ADDENDUM NO. #1

RE: ITB# 016-20 – The Banks Bid Package #6 – Lot 23 Park, Lot 23/27 Garage Signage & Security

Addendum to the Construction Documents

LOT 23 STAIR AND ELEVATOR - PODIUM LEVEL
ROOF PLAN
4
A250
1/4" = 1'-0"
NORTH

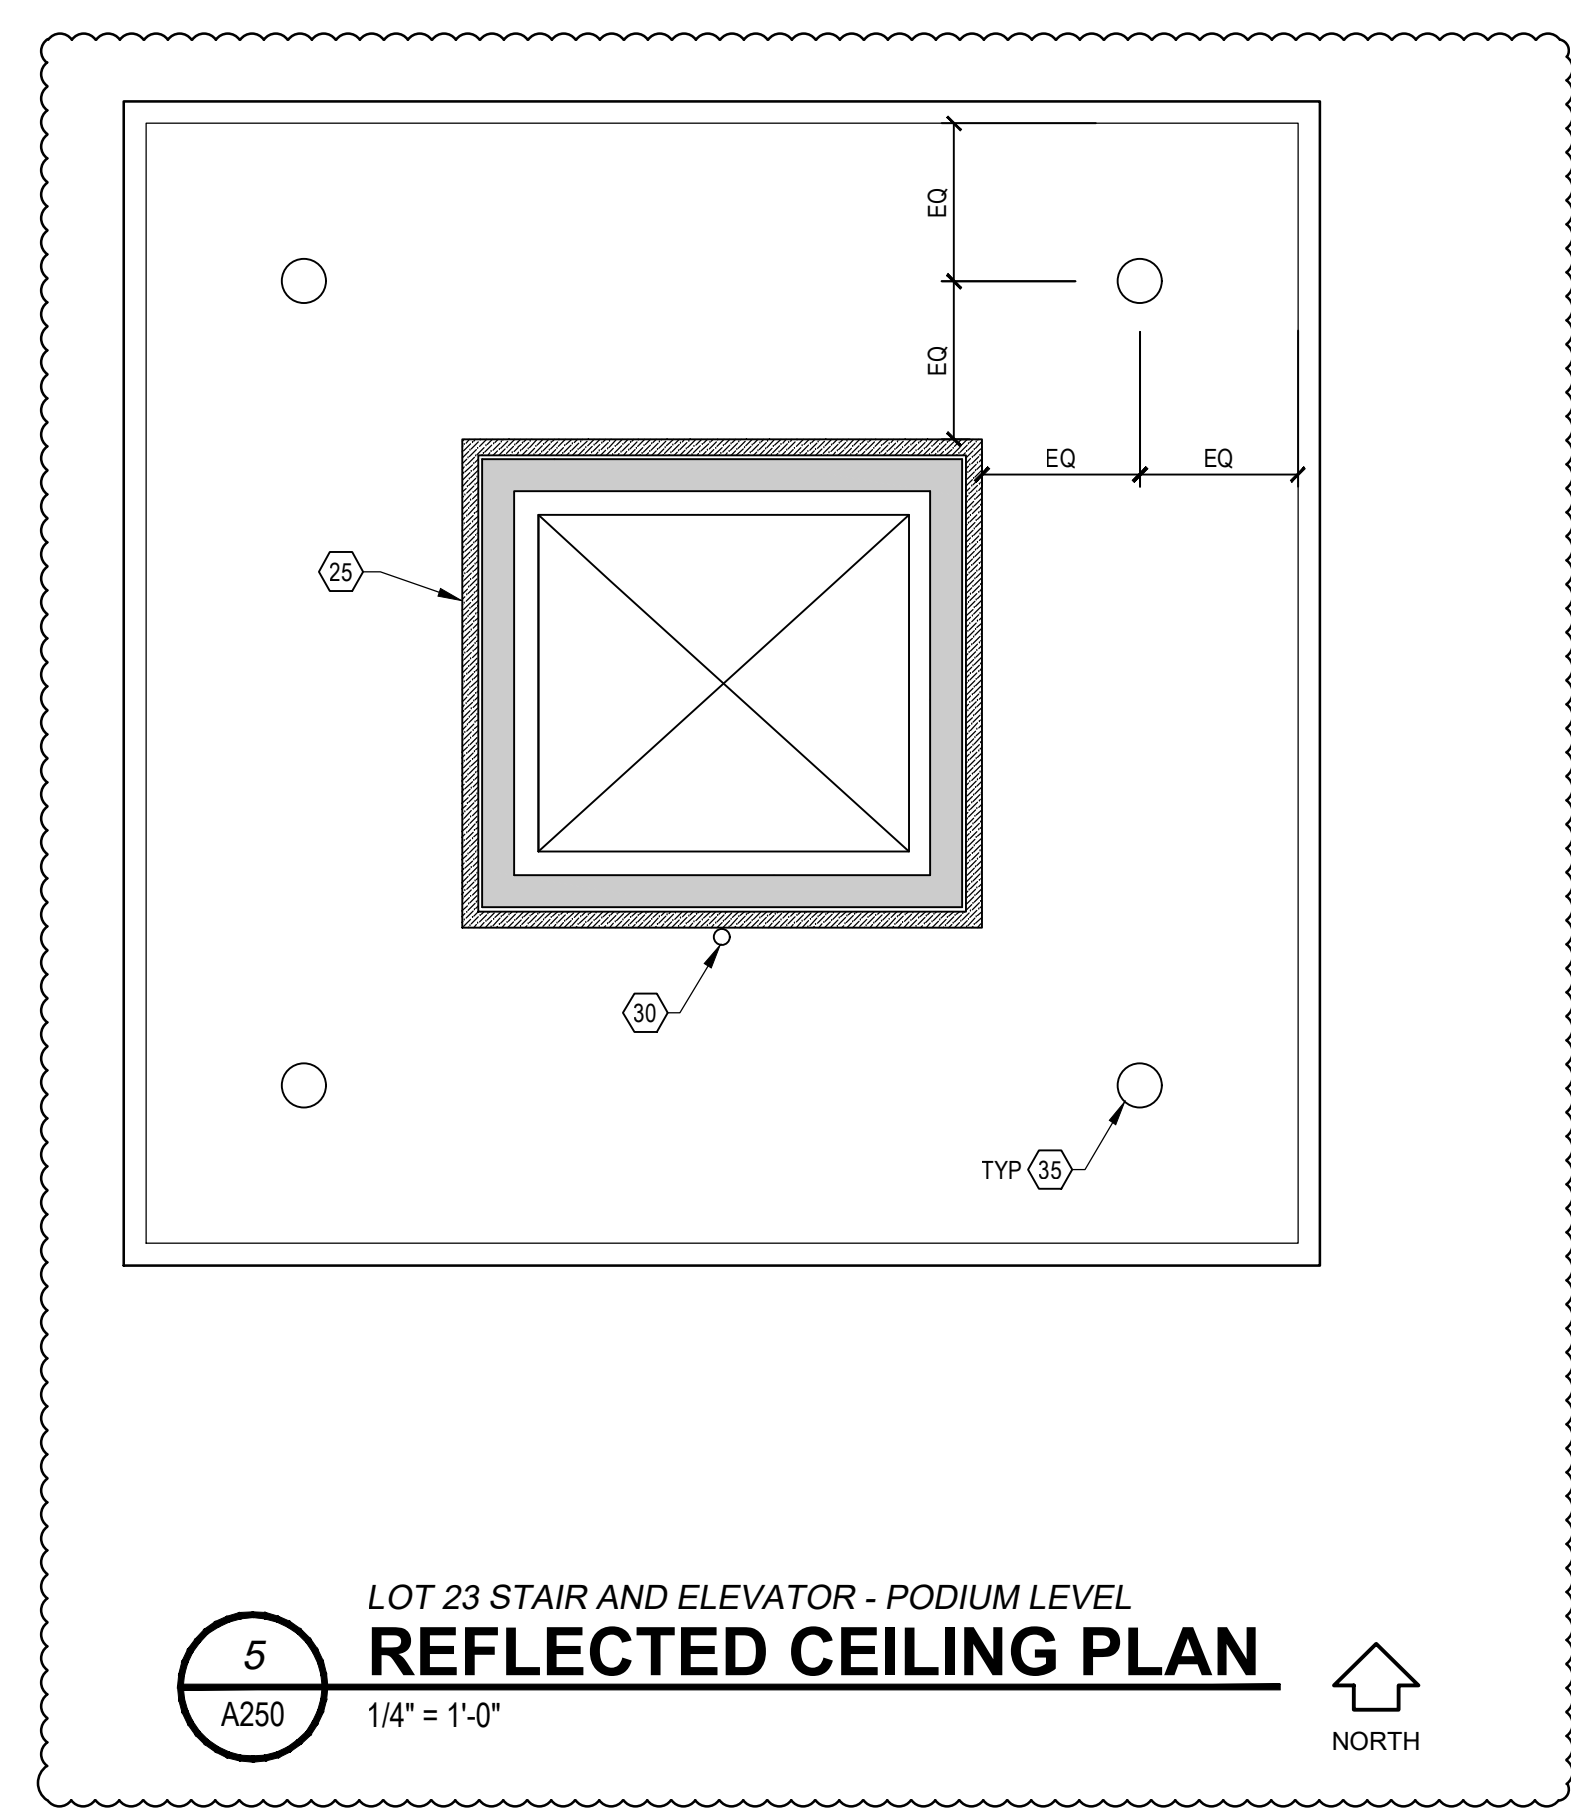
8. Drawing A250: (Drawing Reissued)

- Add Reflected Ceiling Plan.

TY001

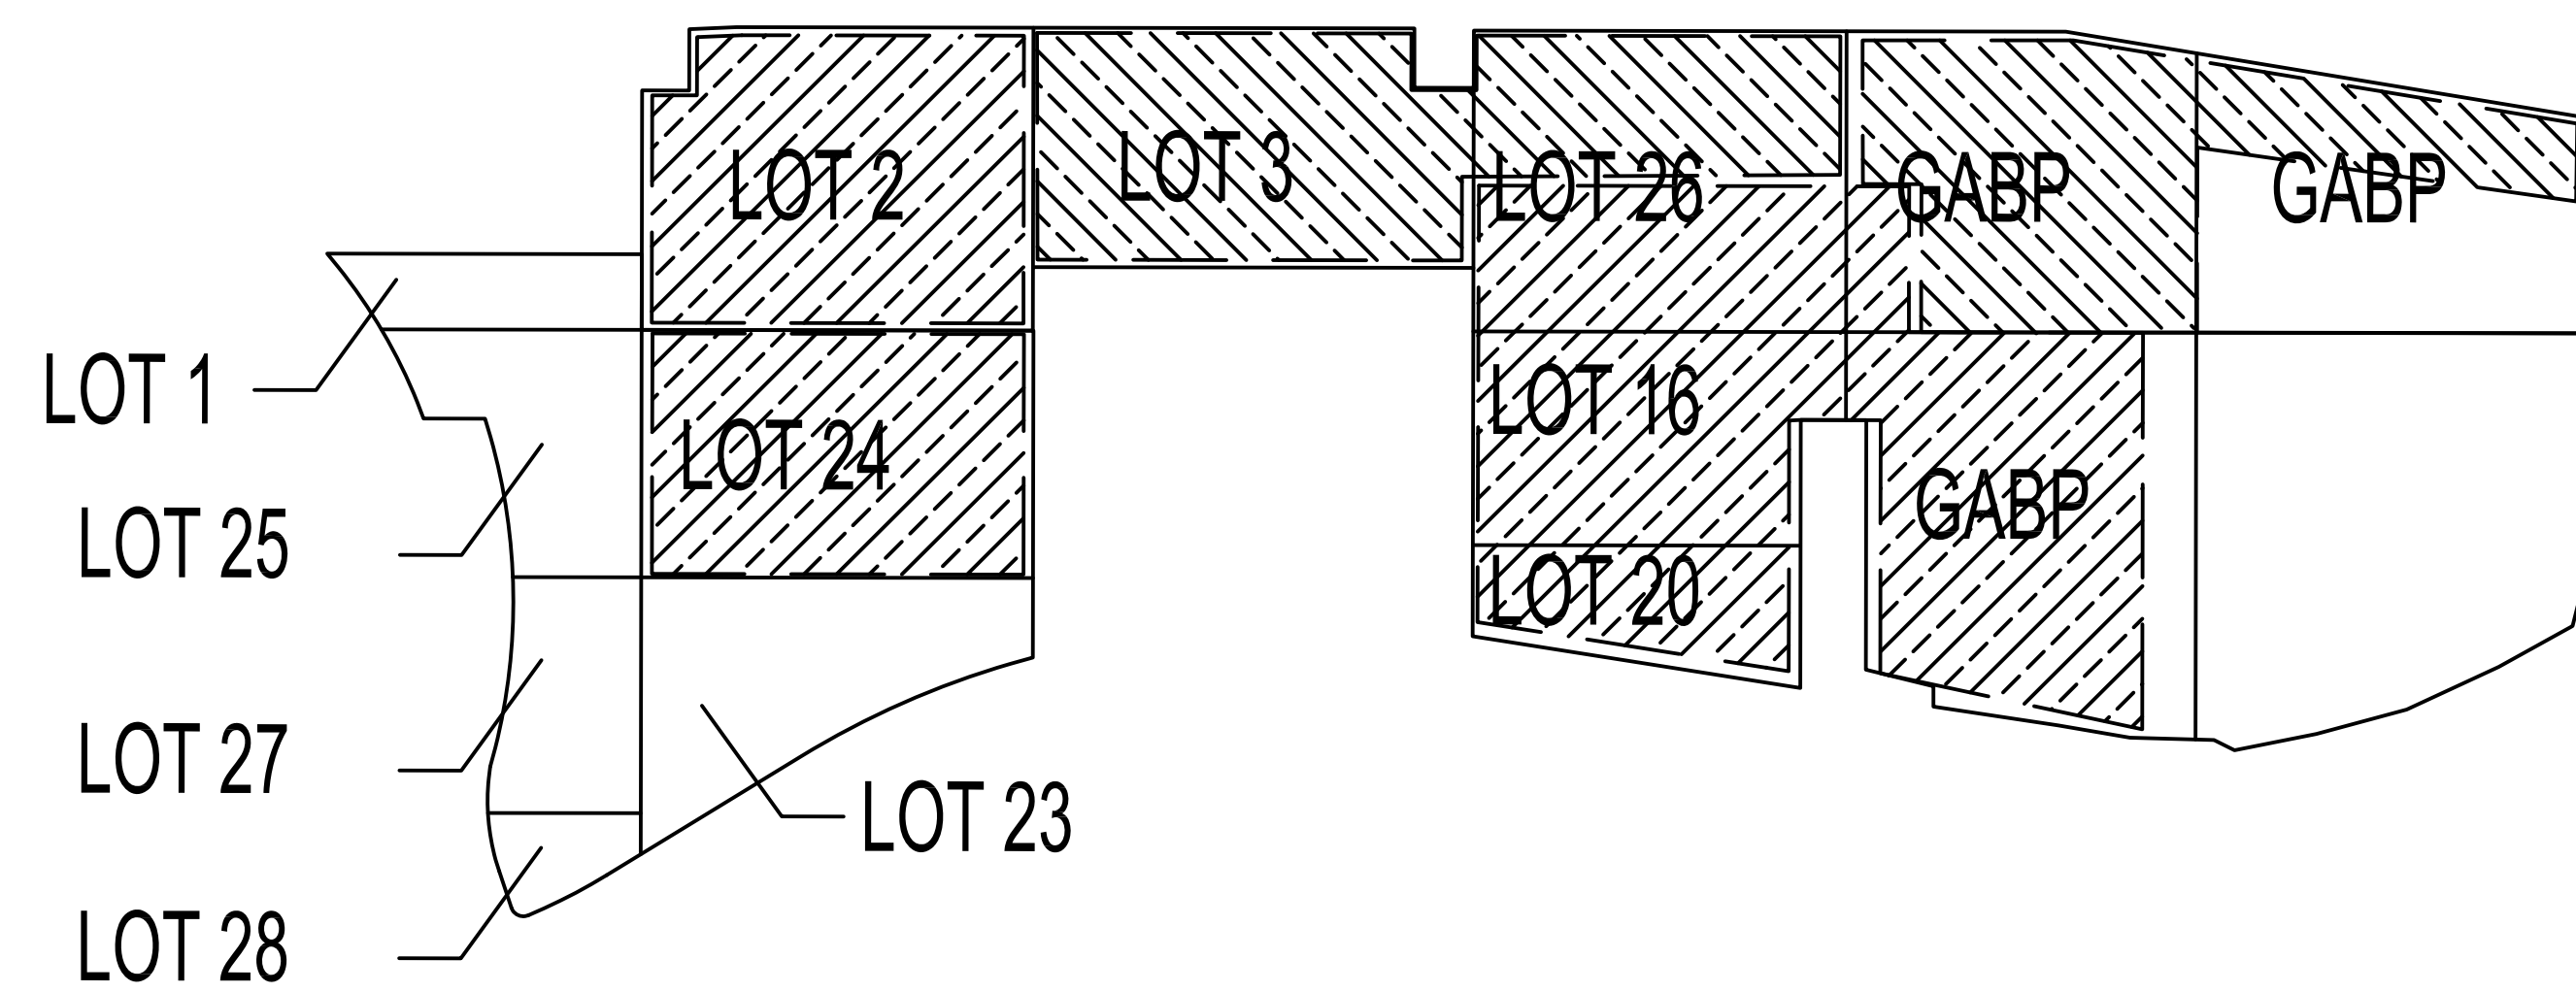
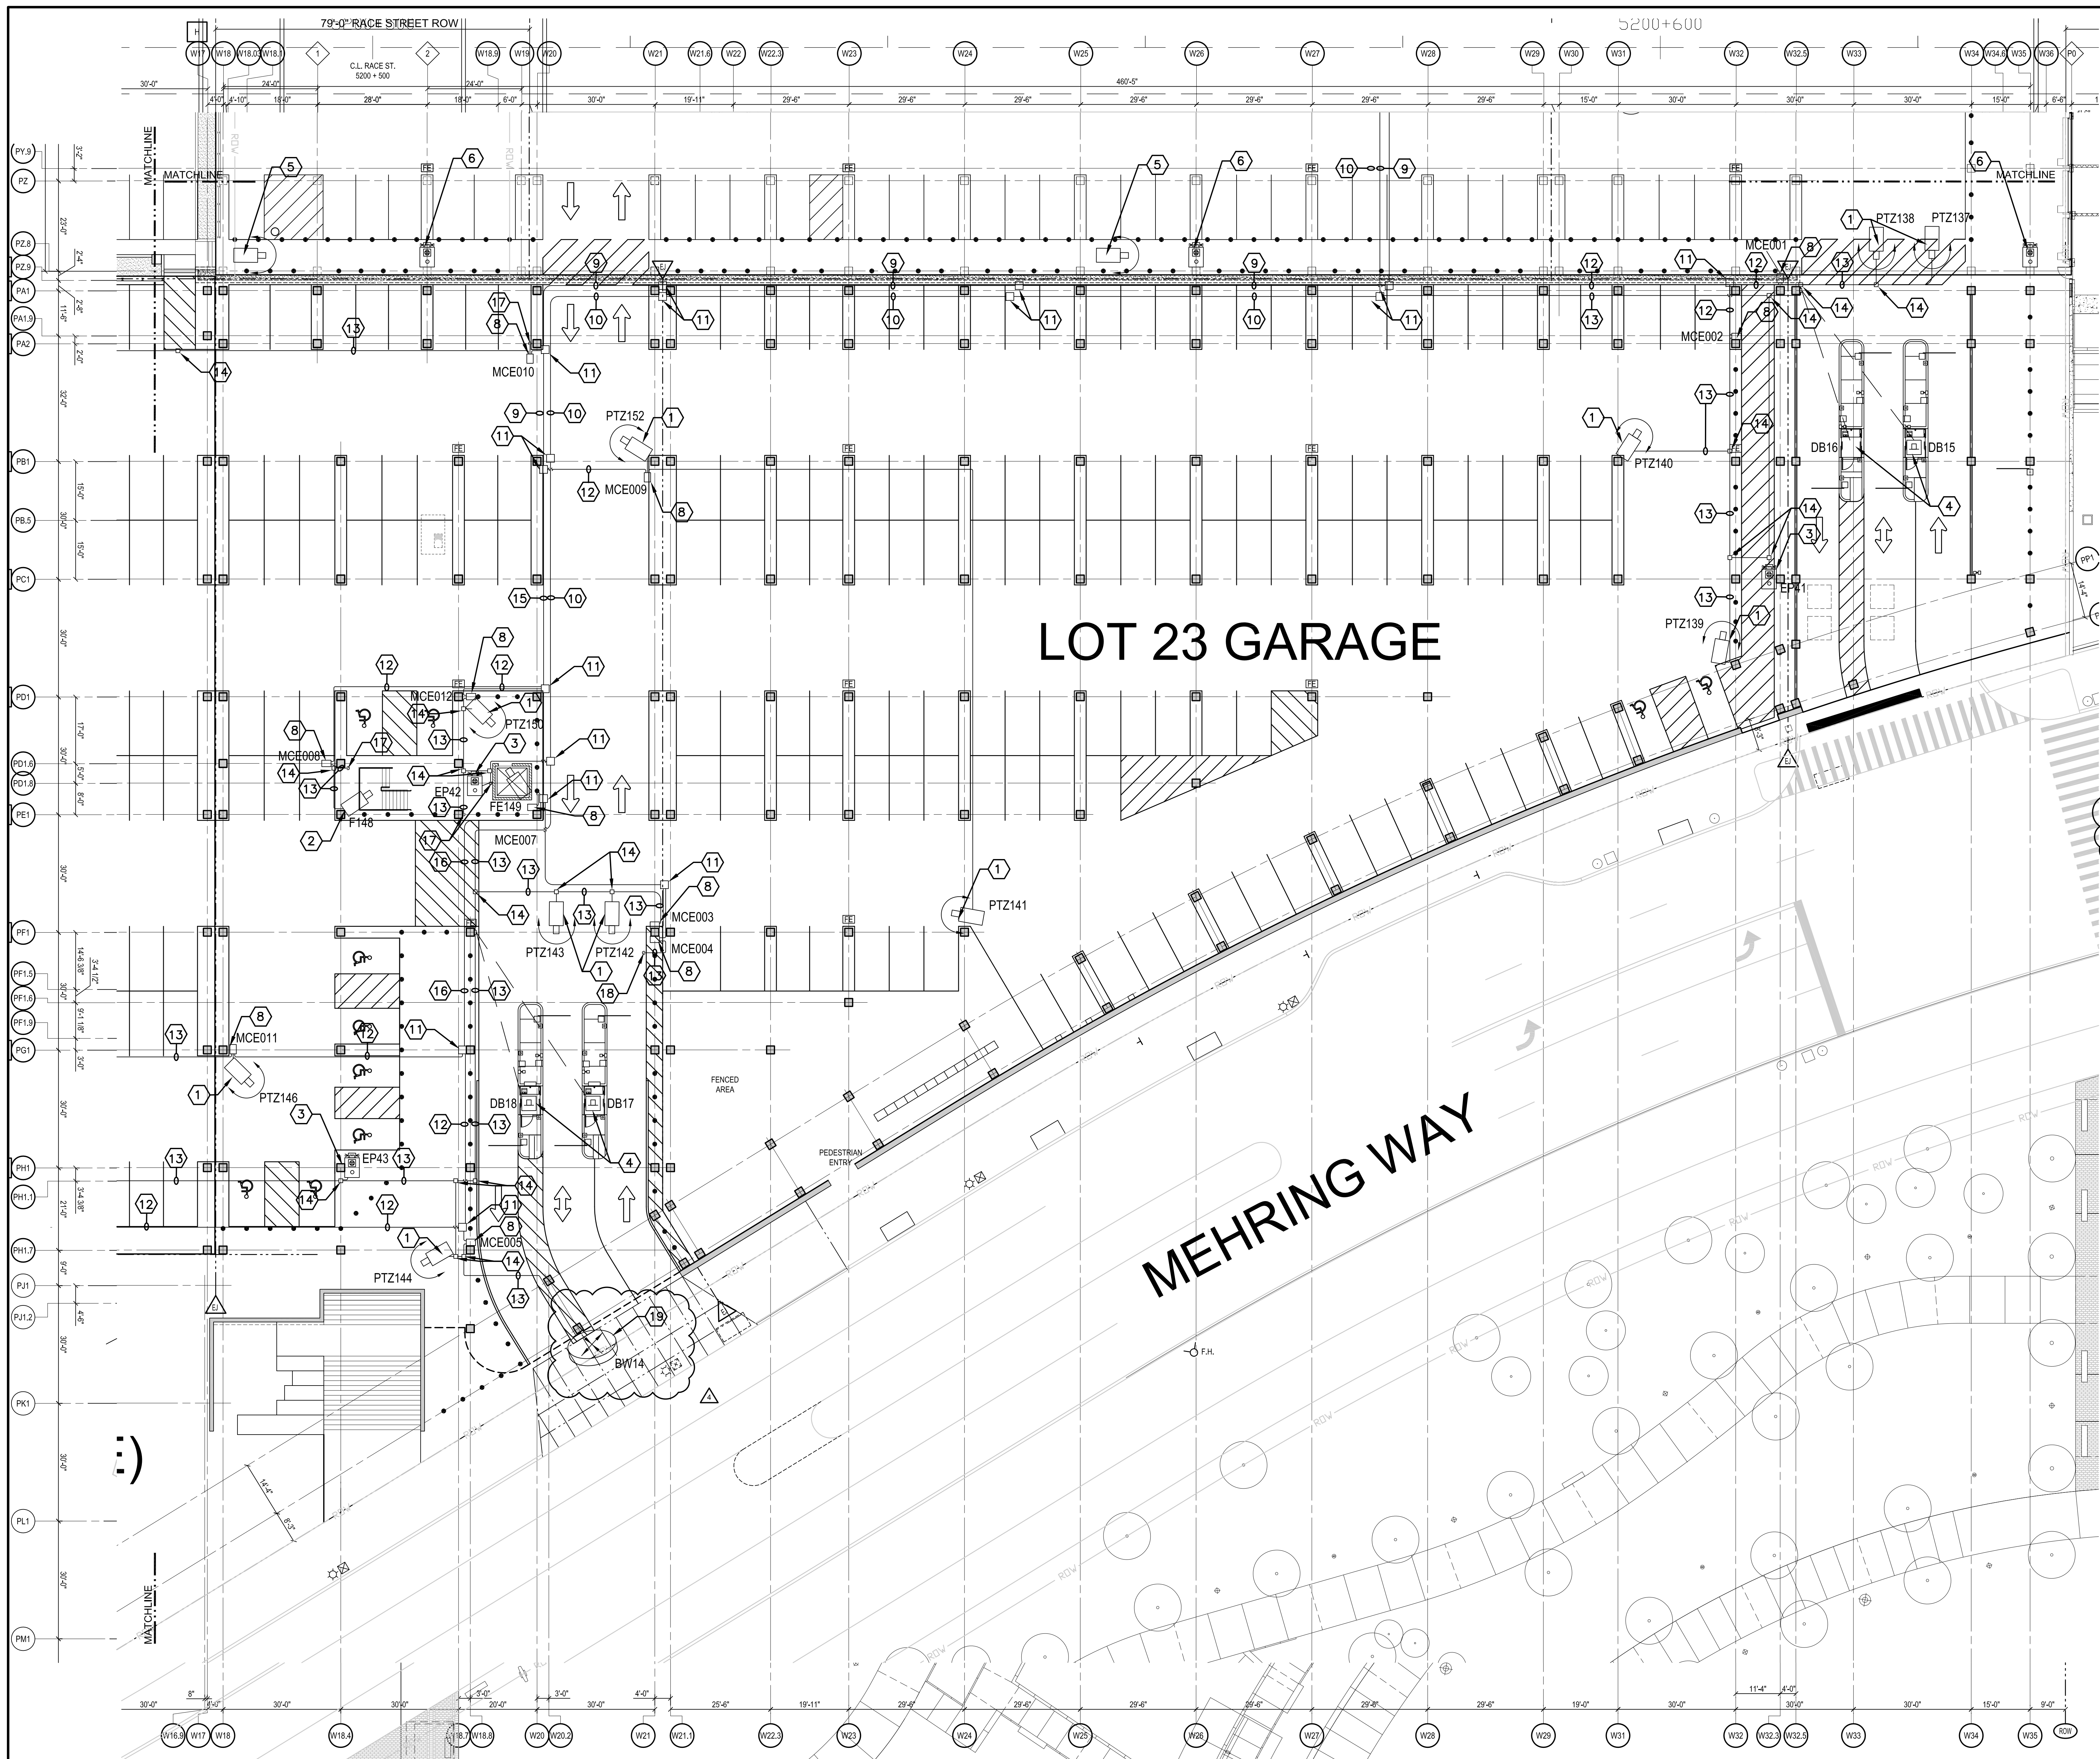
31. Drawing TY001: (Drawing Reissued)

- Revise drawing index to incorporate new sheet TY111A.
